**Project: IEEE P802.15 Working Group for Wireless Personal Area Networks (WPANs)**

**Submission Title:** [MSC figures in draft and updated figures status]

**Abstract:** [MSC figures in draft and updated figures status]

# MSC in D1 draft

### Figure 61—Message sequence chart for performing the dimming function

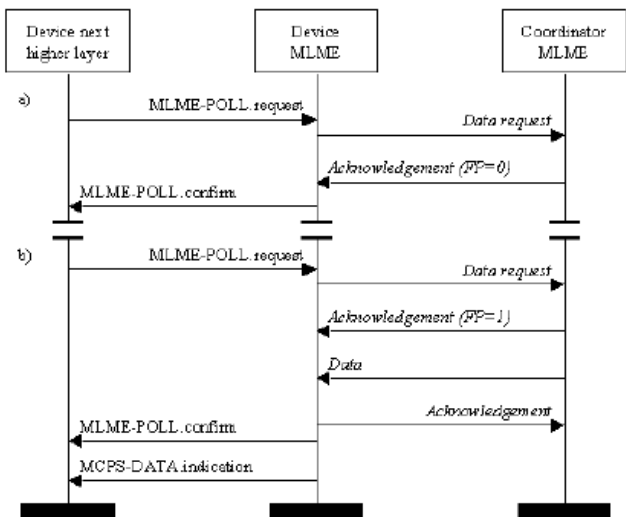
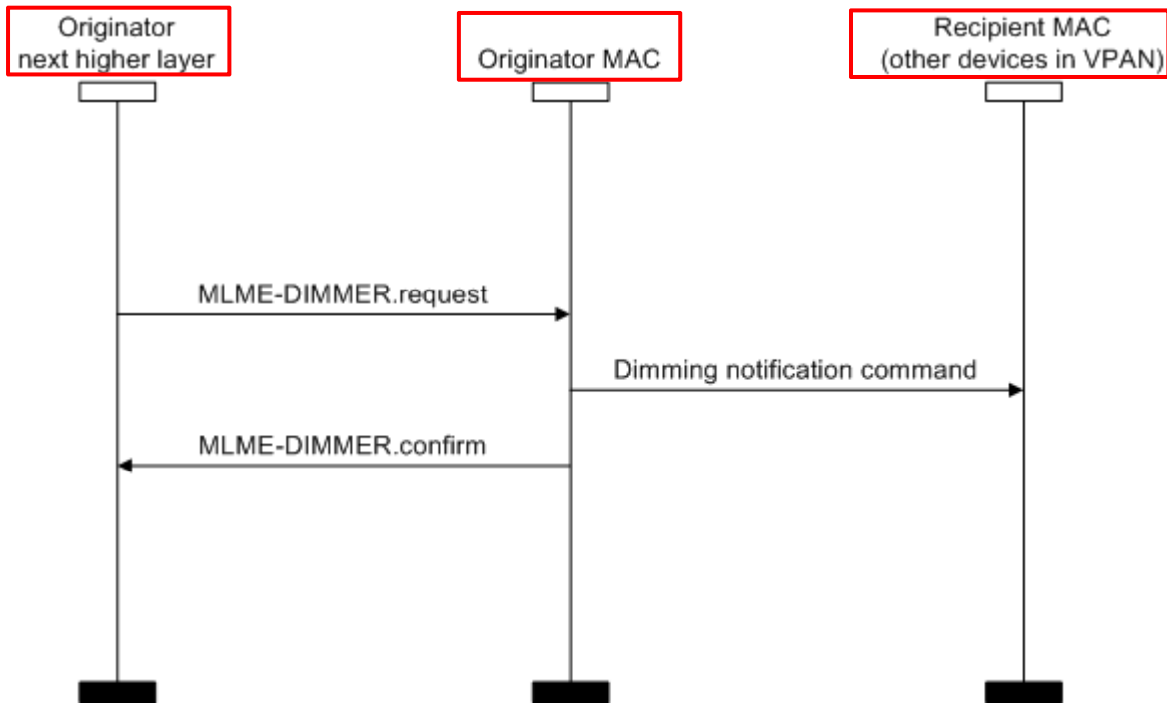
❖ Original figure MSC style : **Wrong Figure.**  
CID 627, 632, 632a

❖ made new figure based on the resolution

❖ Text place in outside box

Figure 109—Starting a PAN

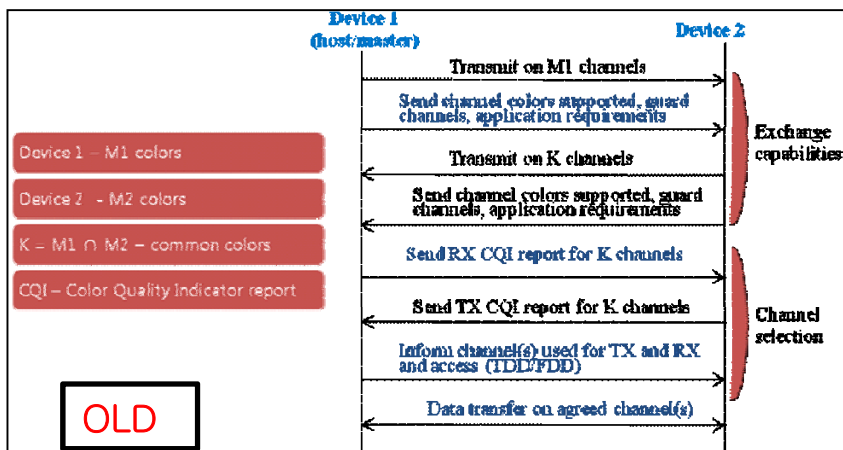
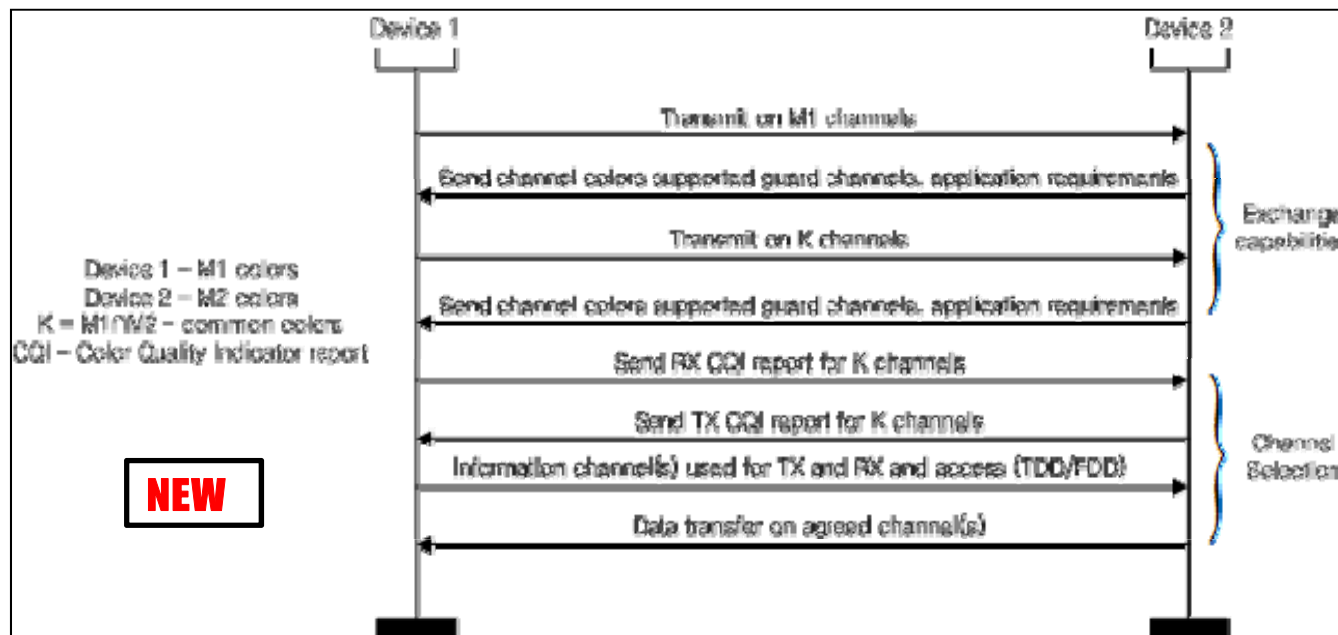
- ❖ Original figure **NOT** a MSC style
- ❖ Re draw a figure
- ❖ No change.

Figure 111—Successful data transmission without an acknowledgment

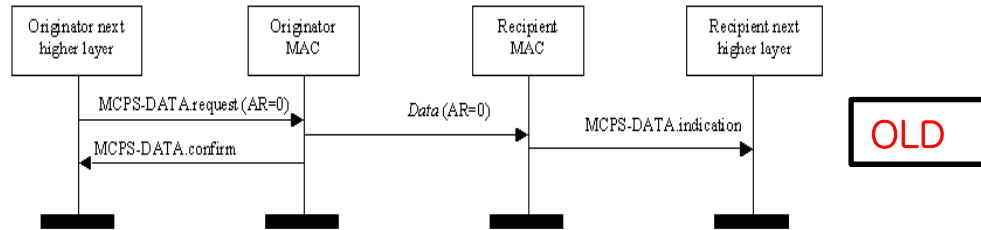
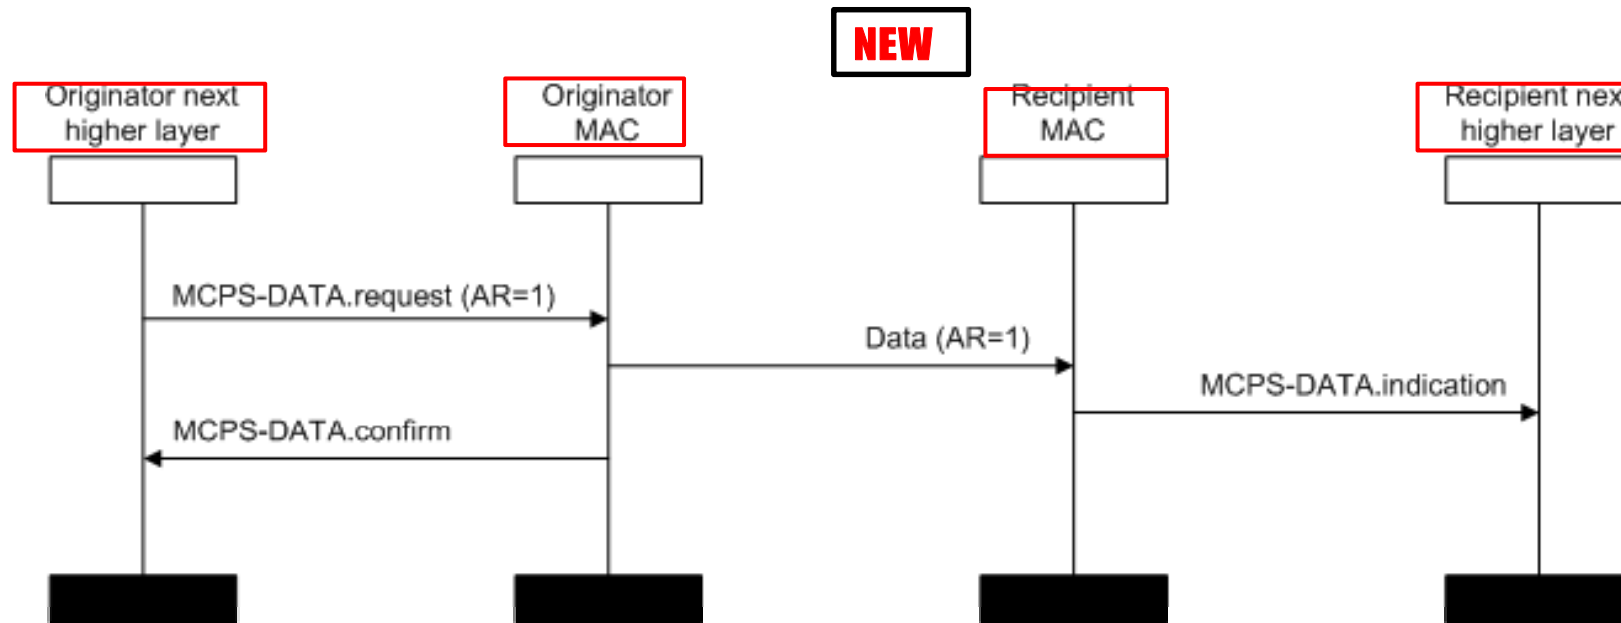
❖ Original figure MSC style :  
Not exist, Not editable.

❖ made new figure

❖ Text placed in outside

Figure 112—Successful data transmission with an acknowledgment

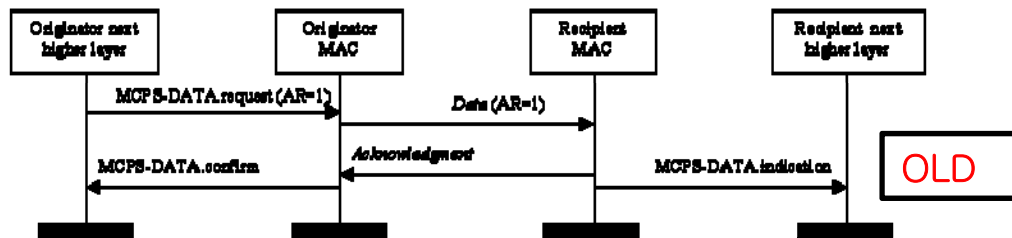
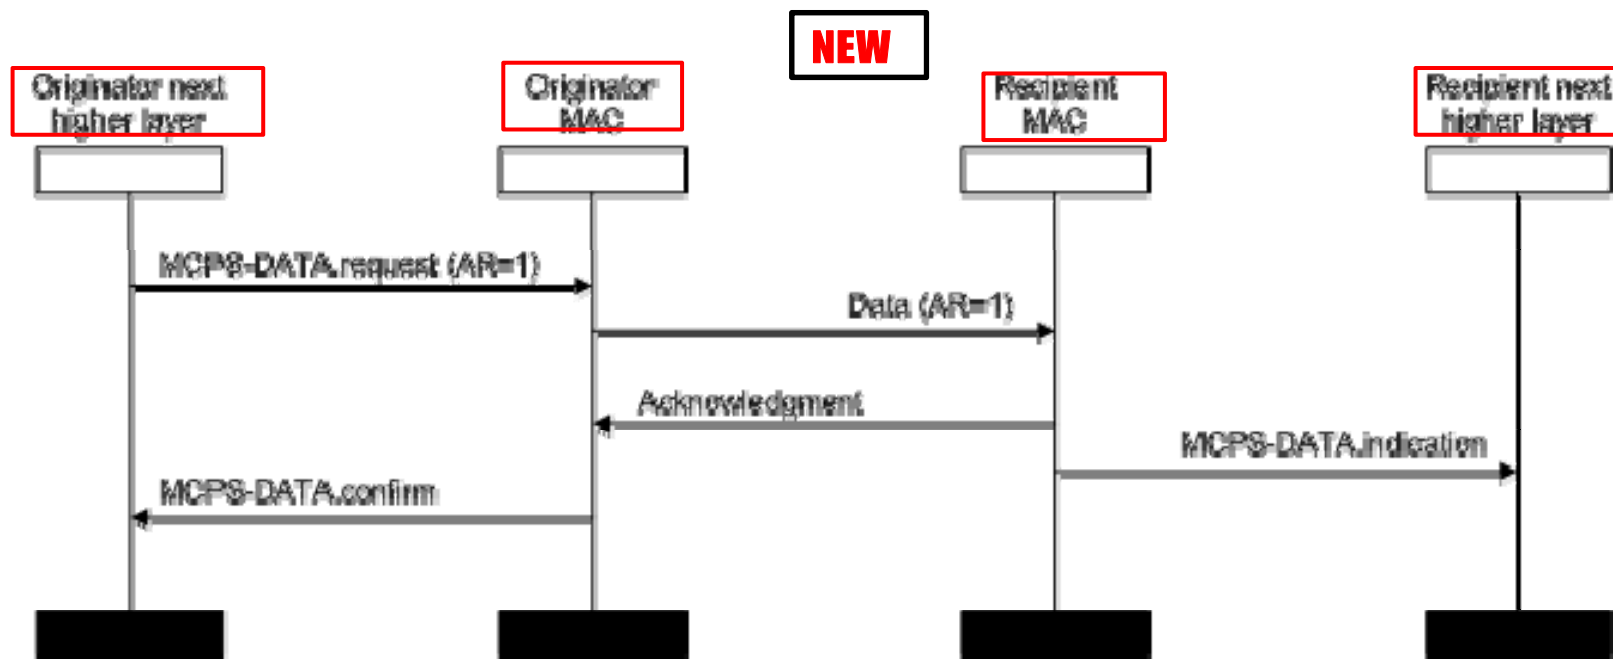
❖ Original figure MSC style :  
Not exist, Not editable.

❖ made new figure

❖ Text placed in outside

Figure 129—Multi-channel information

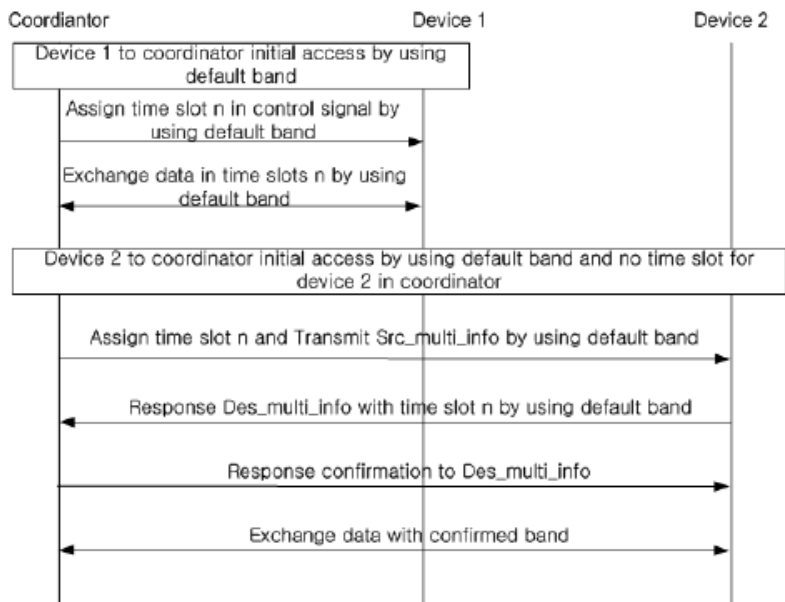
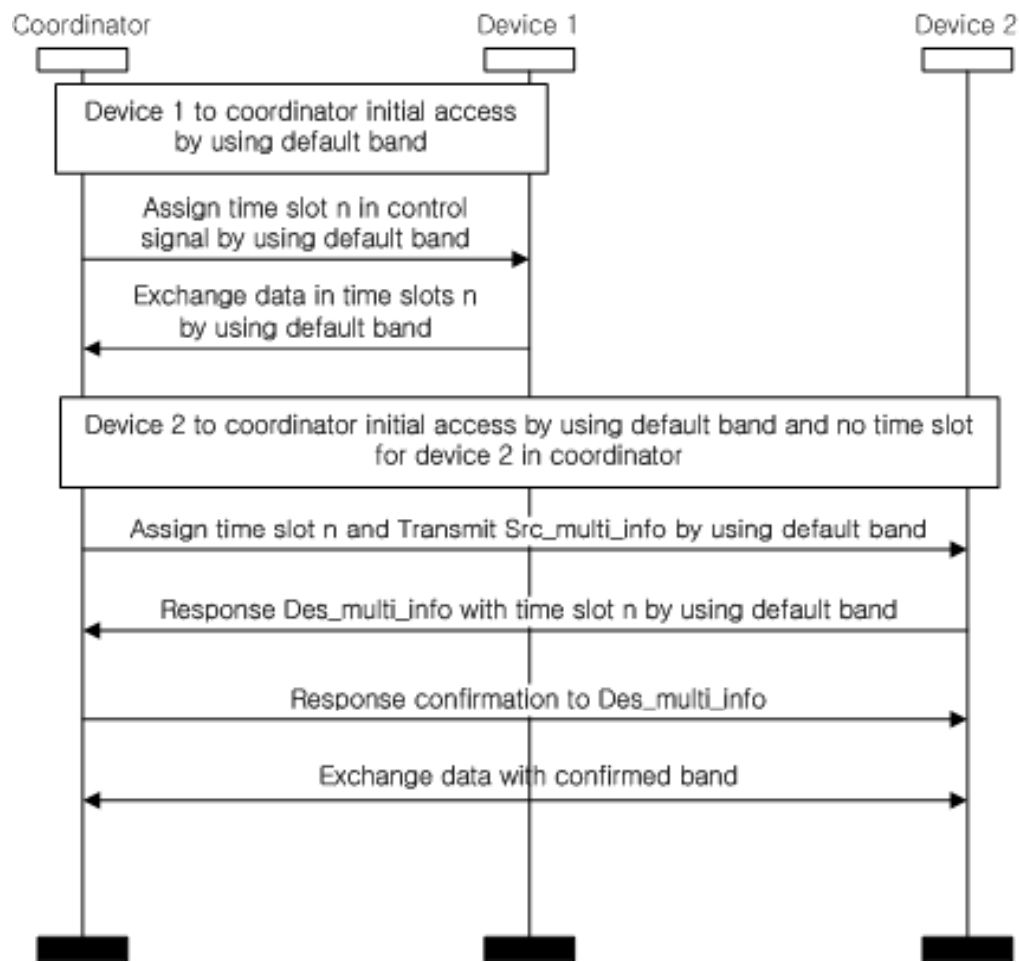
❖ Original figure **NOT** a MSC style

❖ Re draw a figure

Figure 160—Clock rate selection for P2P topology (explicit notification)

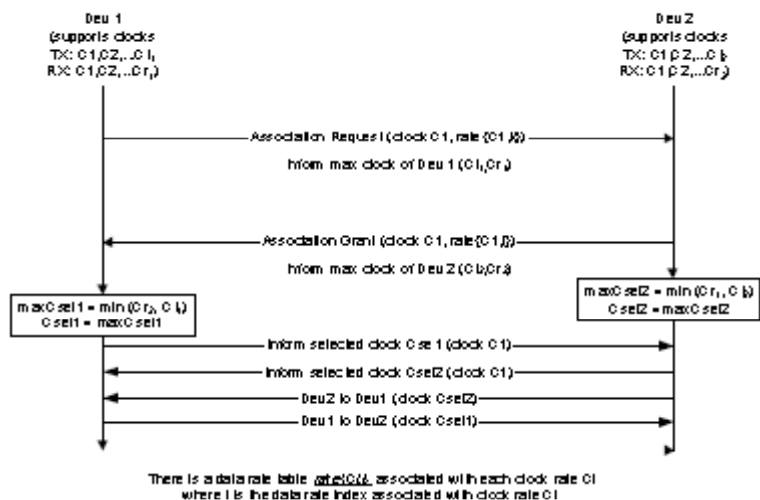
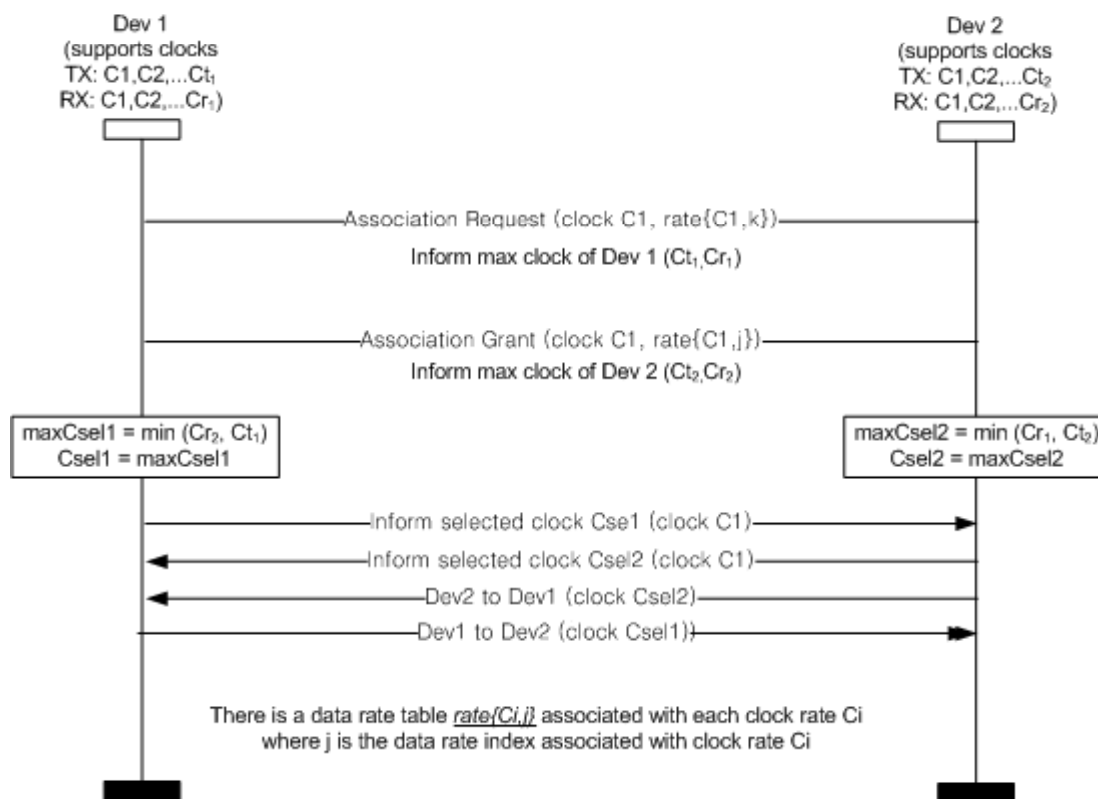
- ❖ Original figure **NOT** a MSC style
- ❖ Re draw a figure

**Figure 163—clock rate selection for star topology (without explicit notification)**

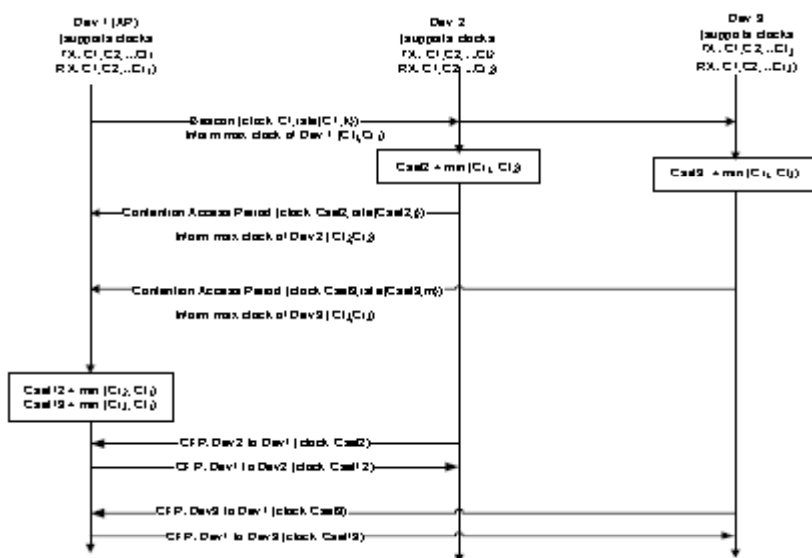
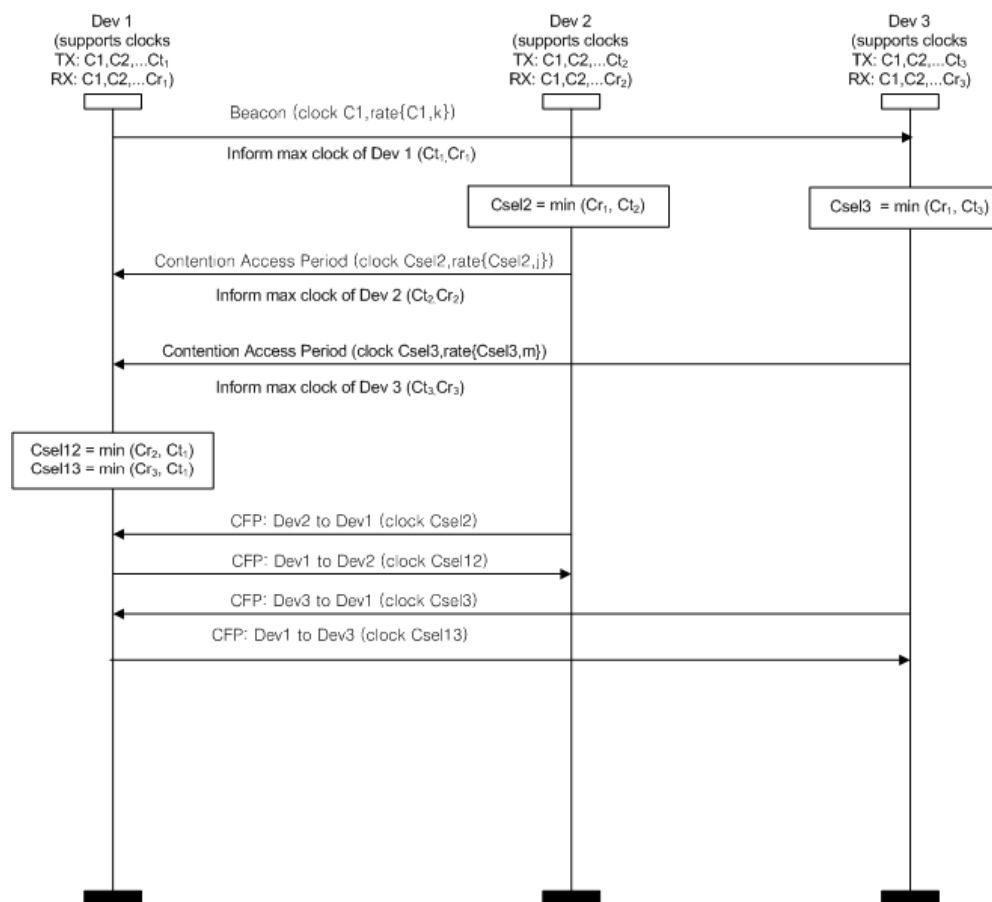
- ❖ Original figure **NOT** a MSC style
- ❖ Re draw a figure

**Figure 164—Clock rate selection for broadcast/multicast (assuming bi-directional communication)**

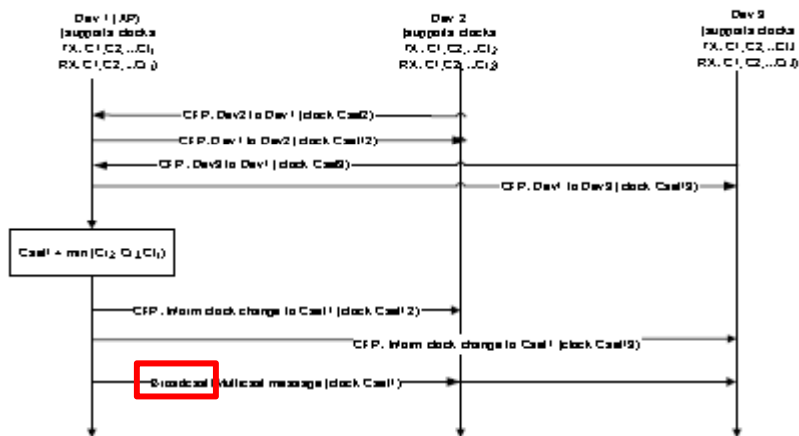
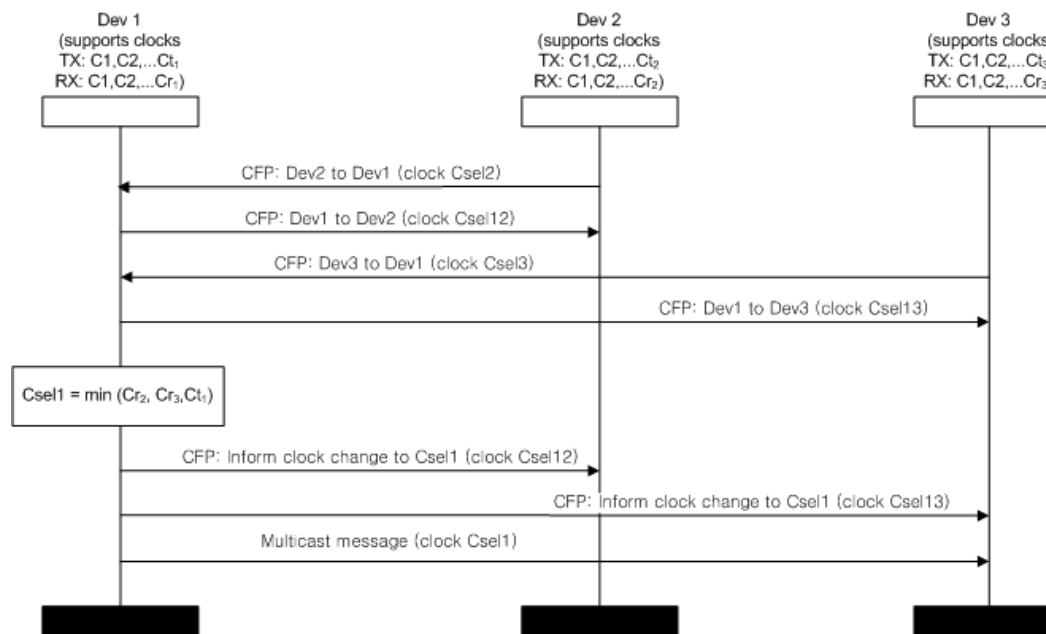
- ❖ Original figure **NOT** a MSC style
- ❖ Re draw a figure
- ❖ Delete Broadcast

Figure 165—clock rate selection for broadcast/multicast (bi-directional communication and no explicit notification)

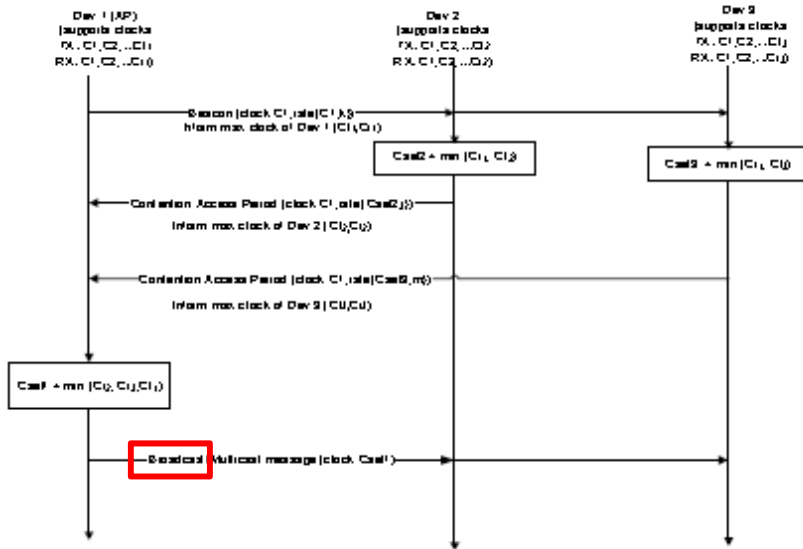
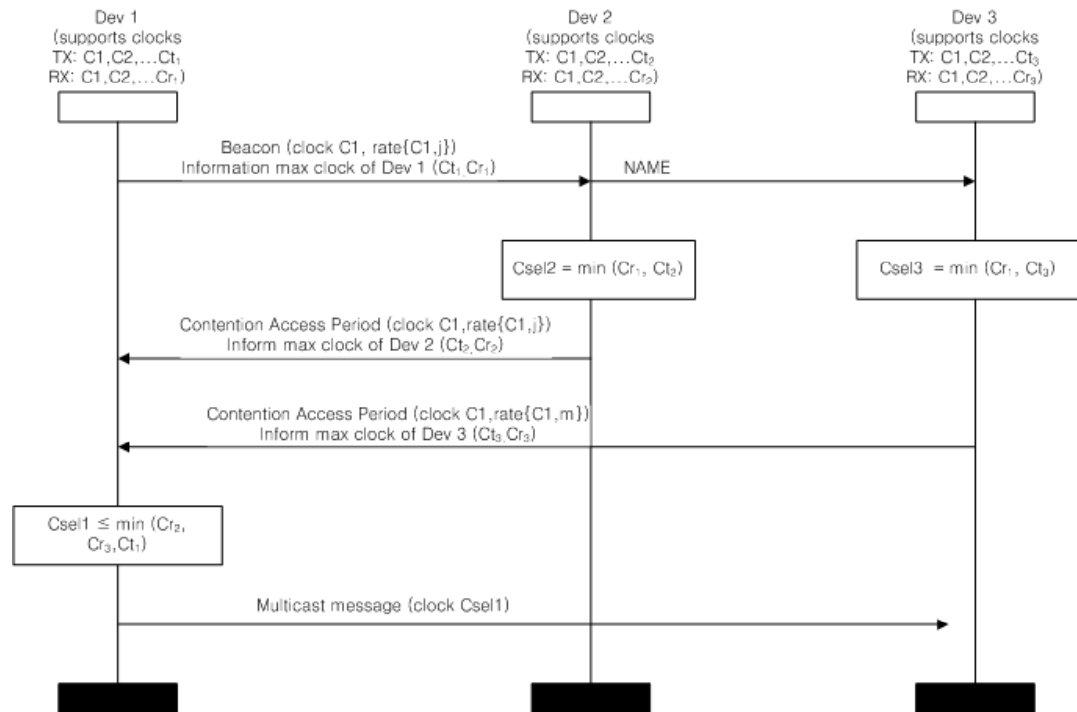
- ❖ Original figure NOT a MSC style
- ❖ Re draw a figure
- ❖ Delete Broadcast
